**APPLICATION FOR
URBAN DESIGN COMMISSION
REVIEW AND APPROVAL**

Responses to UDC draft meeting minutes dated September 20, 2006

**Baer Insurance Building
9701 Brader Way
Lot / Parcel 2 of Blackhawk Church Town Center Plat
Madison, WI**

PLAN NORTH
 1 LANDSCAPE PLAN
 SCALE: 1 : 20

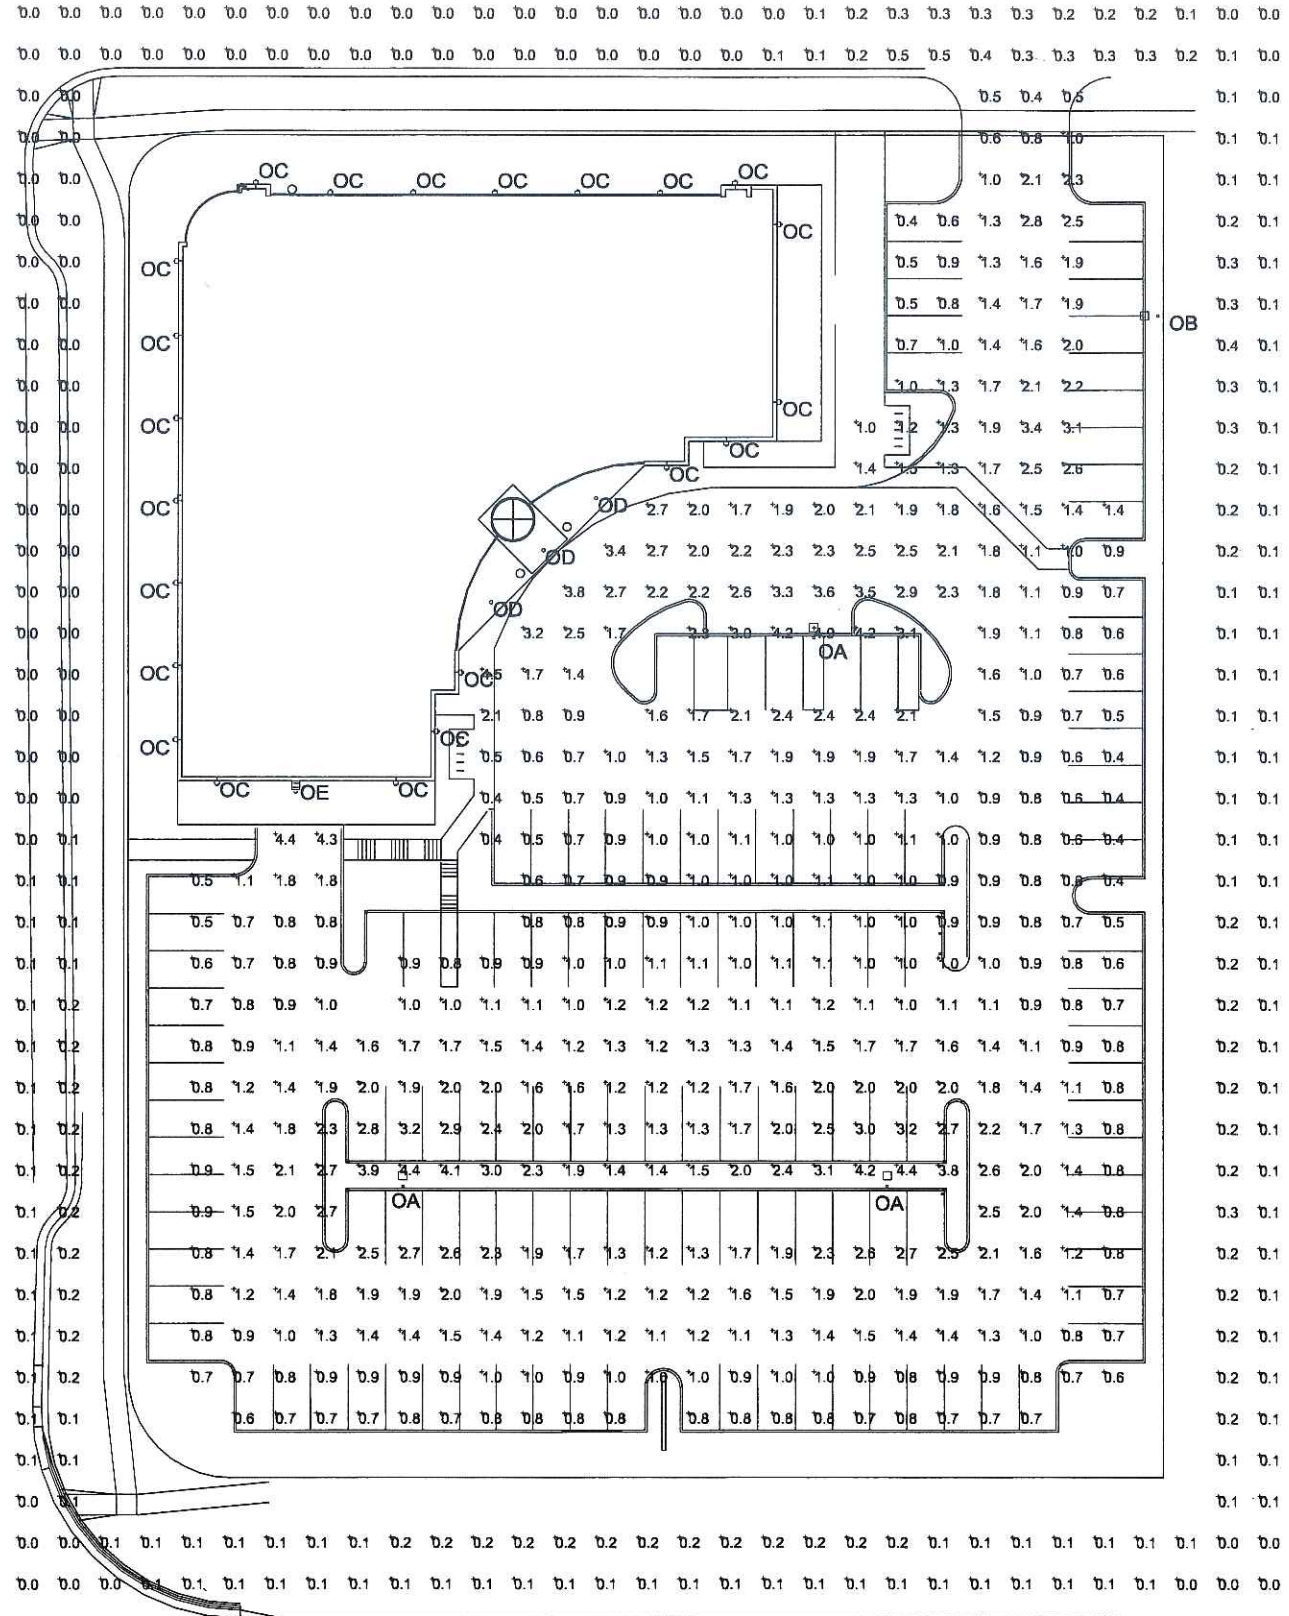
- *Modify the landscape plan to provide for more appropriate plantings within bioswales and infiltration areas as a replacement for lawn.*

The bioswale connecting to the rain garden has been moved down to the southern end of the property. Bioswales are not feasible within the interior islands due to the natural excessive grade of the site. Infiltration is not feasible on the site due to the clay soils beneath the site, which do not allow for infiltration.

1
A2.1
FIRST FLOOR PLAN
SCALE: 1/8" = 1'-0"

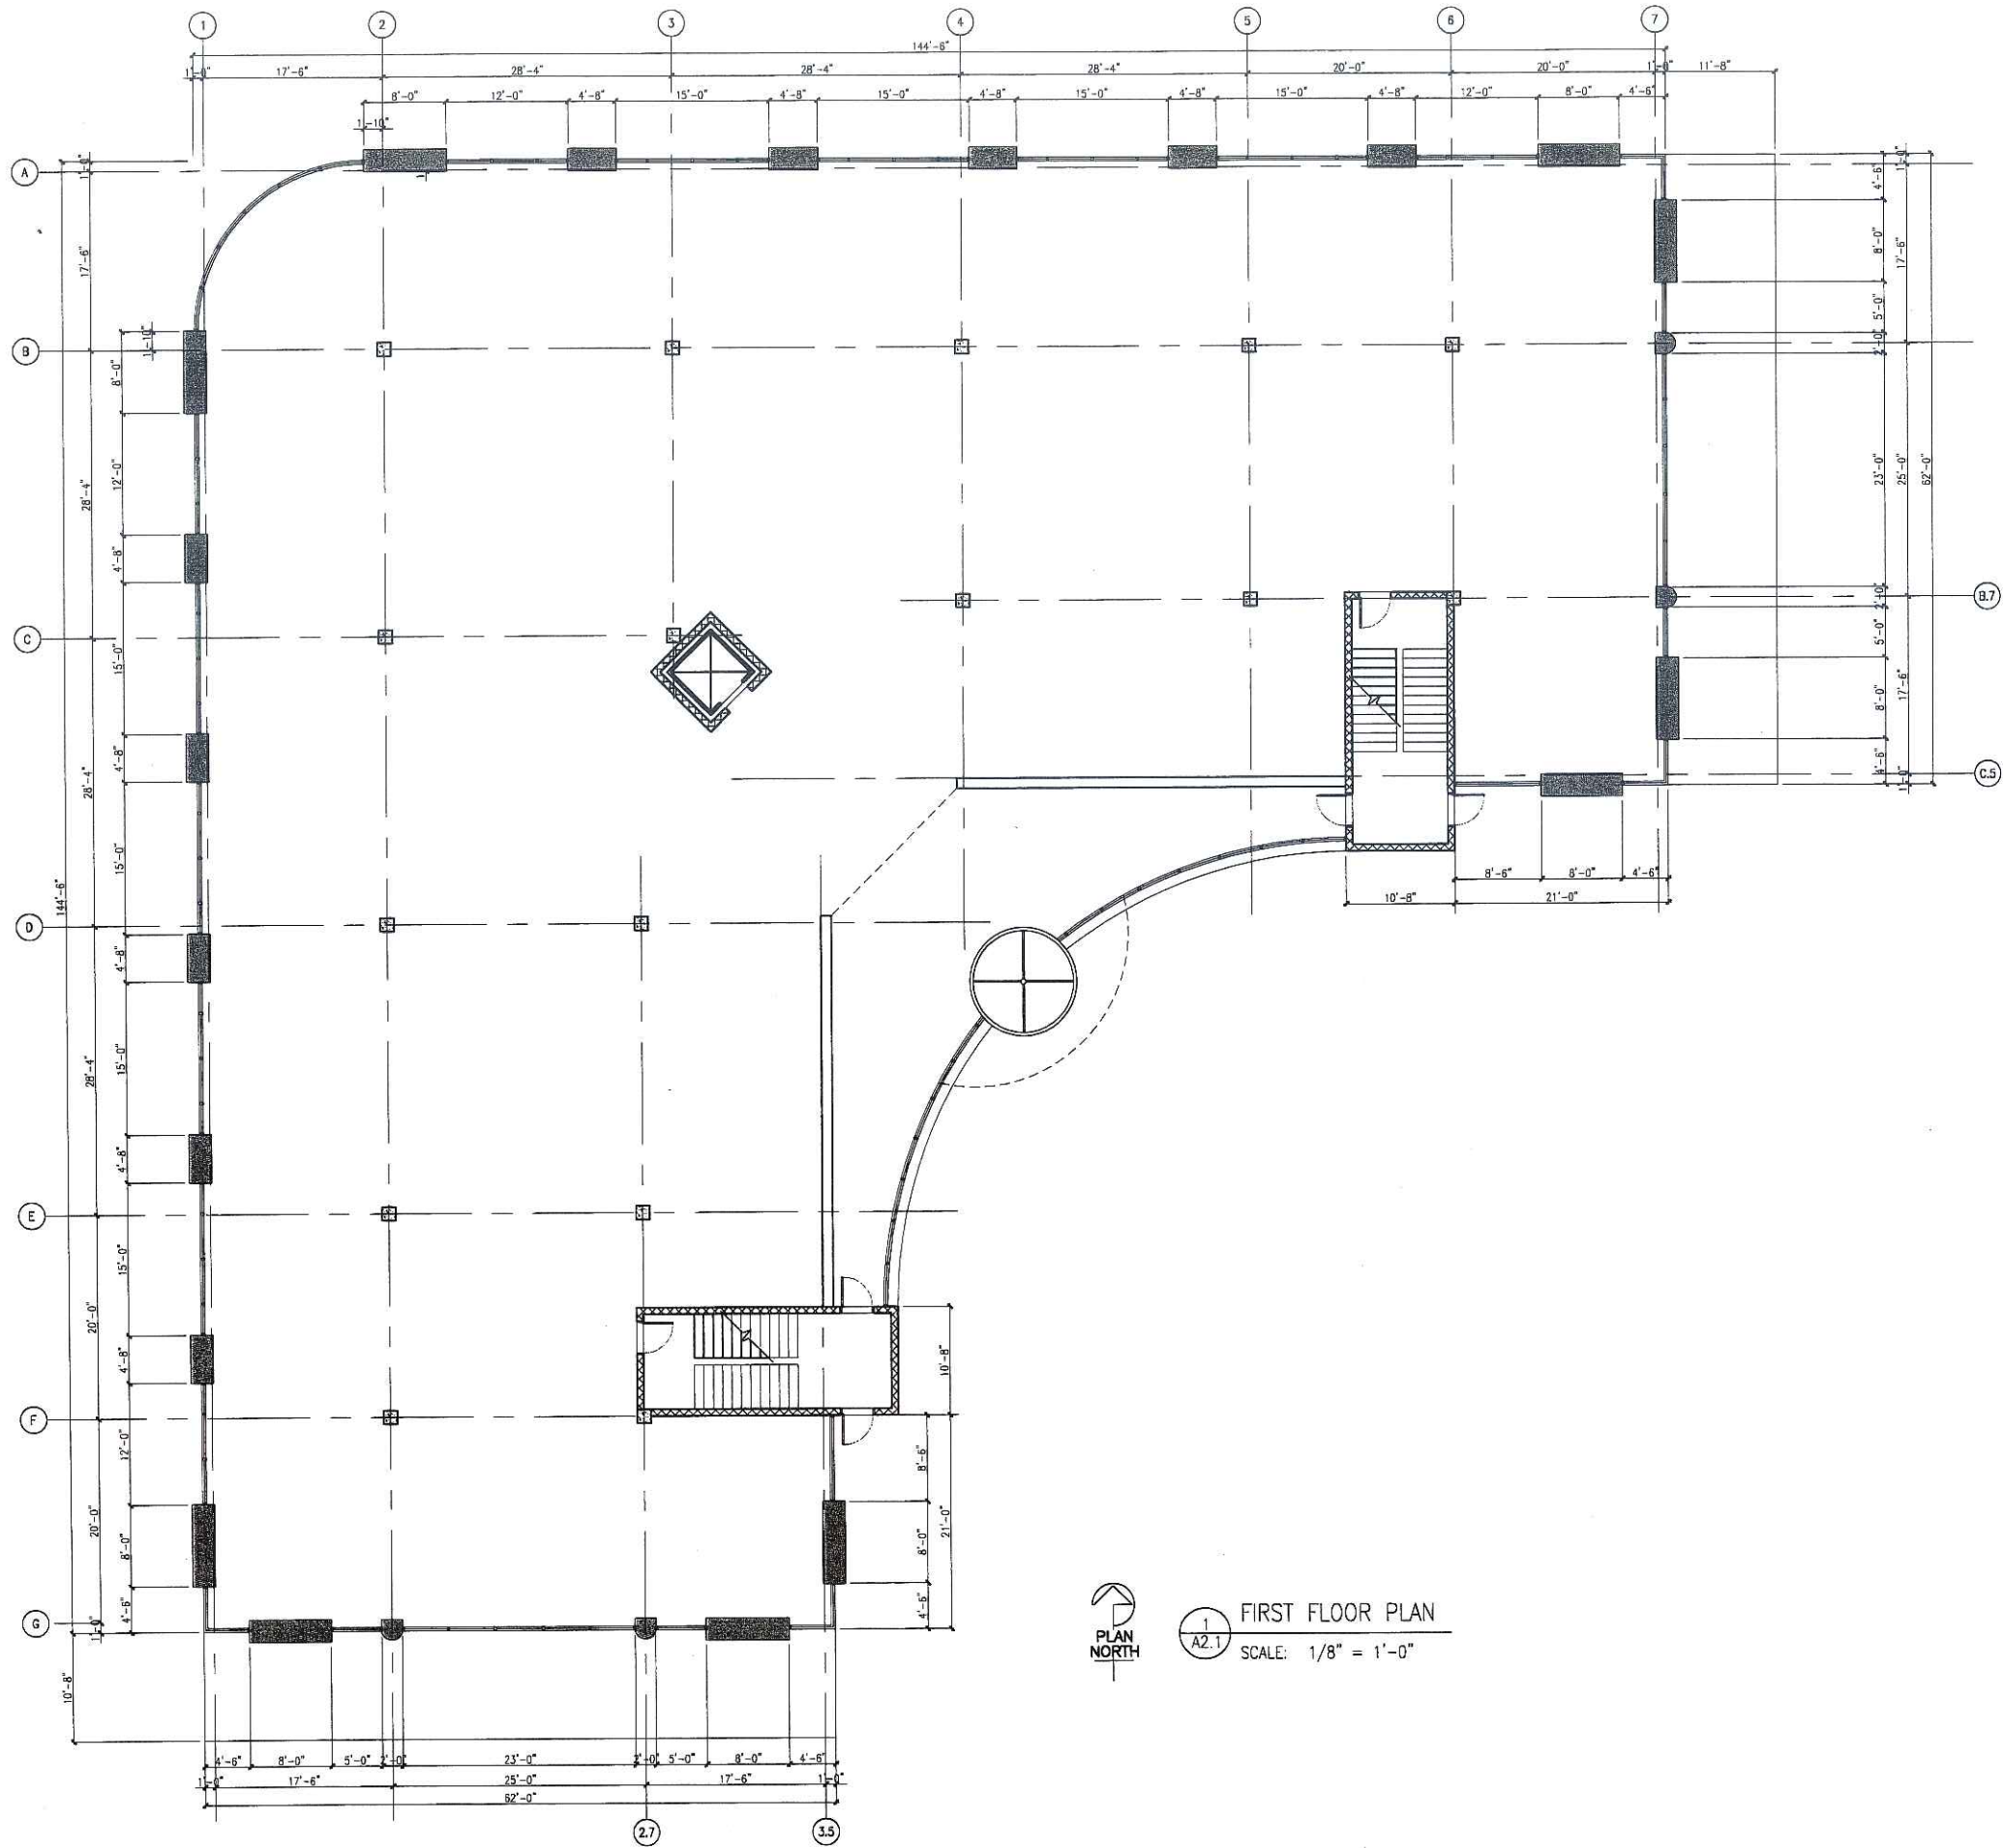
- *Corner entrance issue needs to be addressed appropriately.*

- *Building was intended to provide more of an urban feel. Building doesn't address corner at all; need to engage its other sides (street sides).*

An entrance has been added to the north side of the building, to access Brader Way.

An entrance has been added to the north side of the building, to access Brader Way. In case the first floor tenant and/or use should change in the future, this same entrance type could be used in the other first-floor bays to provide street access.

1 NORTH ELEVATION
A4.1
SCALE: 1/8" = 1'-0"

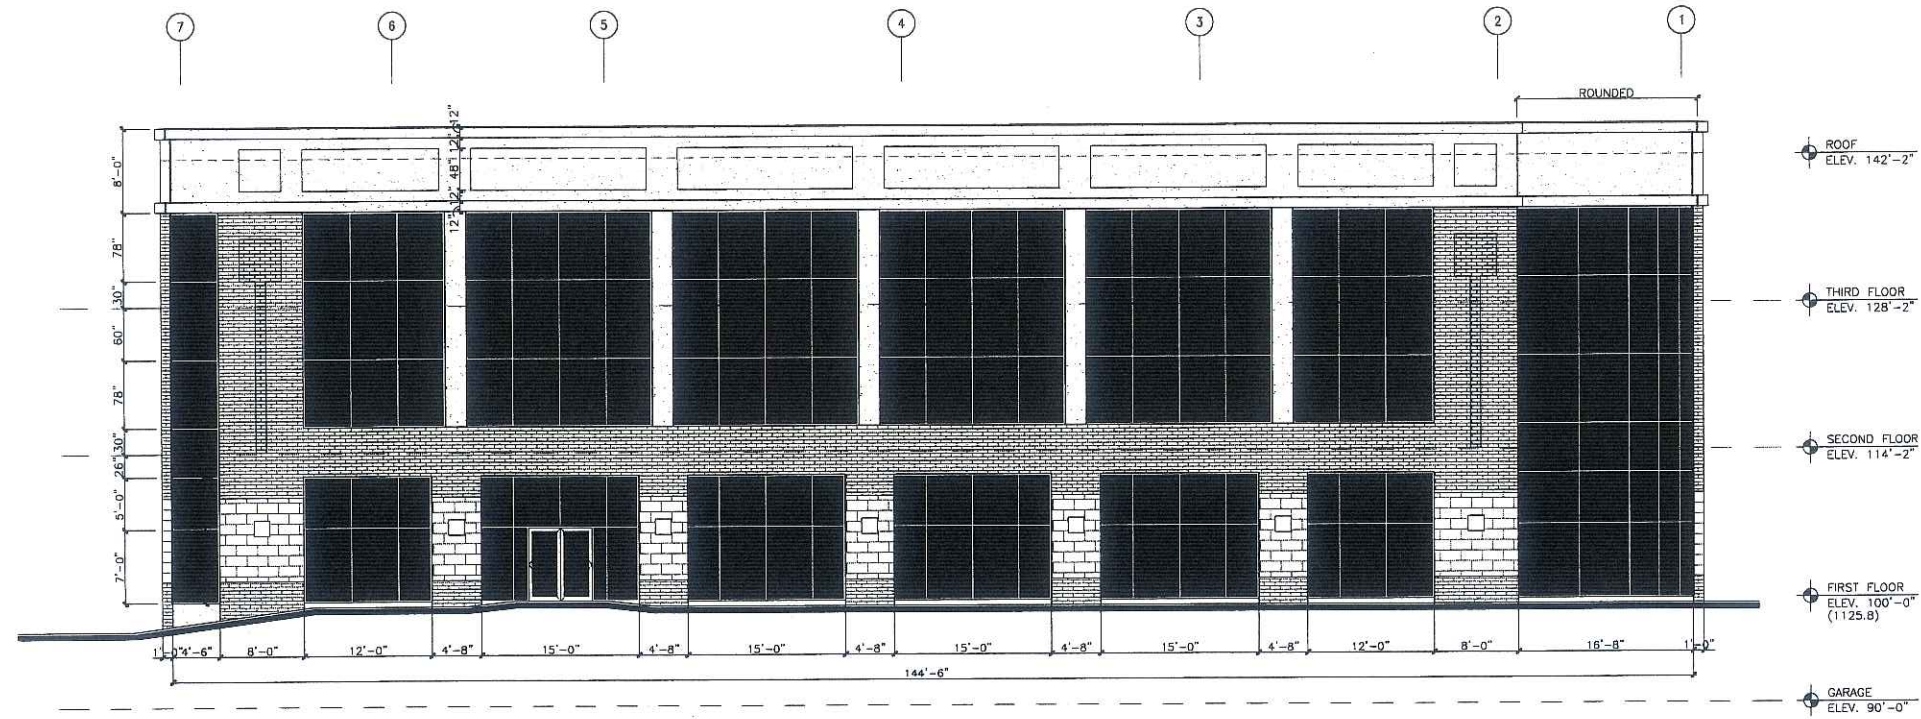
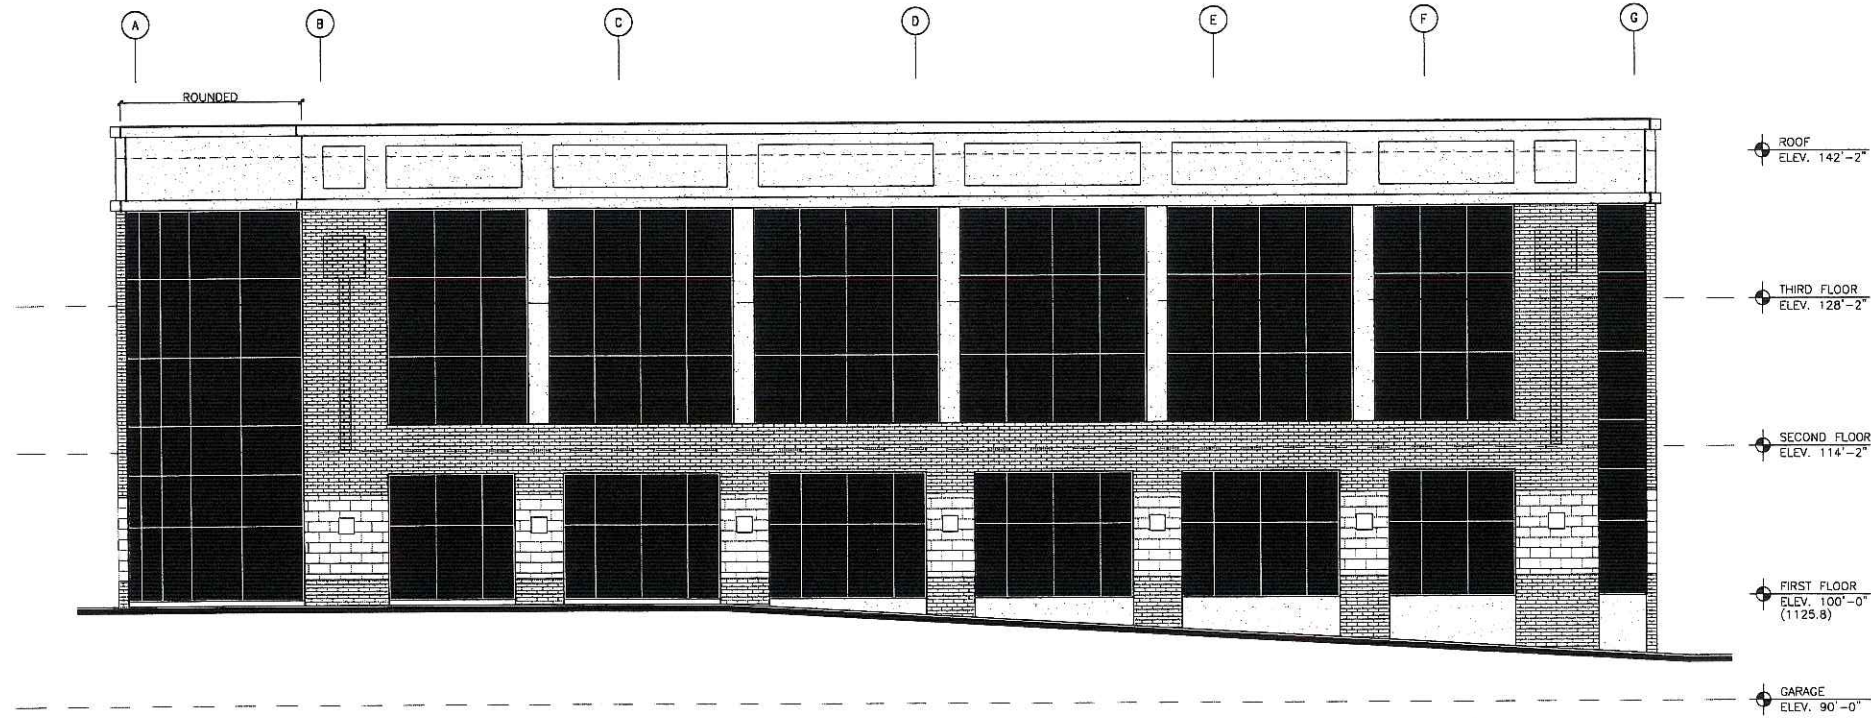
- *Given size of building, question the appropriateness of the size of brick needed, modular.*

- *Provide elevation details necessary to show the size of brick.*

The actual brick sizing, a 4"x12" nominal size, has been show on the 1/8" scale elevations. I believe that this is an appropriately scaled brick for a 3 story commercial building in an "urban" setting. The standard modular size brick is a more residential-scaled application.
